**CITY OF SNELLVILLE
DEPARTMENT OF PLANNING & DEVELOPMENT
PLANNING COMMISSION**

CASE SUMMARY

| CASE NUMBER: | #RZ 24-05 SUP 24-03 RZ 24-06 |
| DEVELOPMENT/PROJECT: | Stacked Townhouse Style (Stacked Flats) with 14,000 SF Commercial Building |

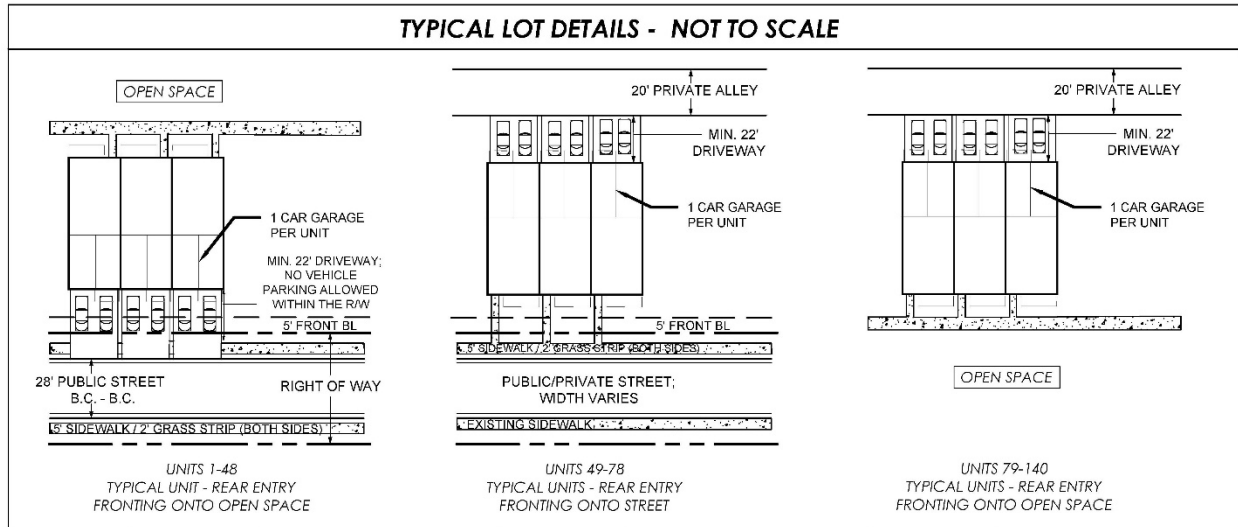
The conceptual rezoning site plan dated 11-8-2024 for Bethany Park shows the layout of the 8.95± acre site with a 14,000 sq. ft. commercial building and related parking located at the northern portion of the site at the intersection of Civic Drive and E. Main Street and 140-unit stacked-townhouse-style (stacked flats) in ten (10) buildings located on the remainder of the site, with each building containing between ten (10) and sixteen (16) dwelling units

The proposed 20-foot wide private alley, measured back-of-curb to back-of-curb, serving as the primary vehicular access drive, may not be wide enough to safely accommodate unit parking (Units 55-70 and Units 113-134) due to the location of the parallel (guest) parking. Further, as alleys primarily serve as a secondary means of vehicular access with reduced width, design and use of a local urban street with a wider pavement width¹ may be more appropriate and functional for both two-way vehicular traffic, unit driveway entry/exit, and guest and overflow parking.
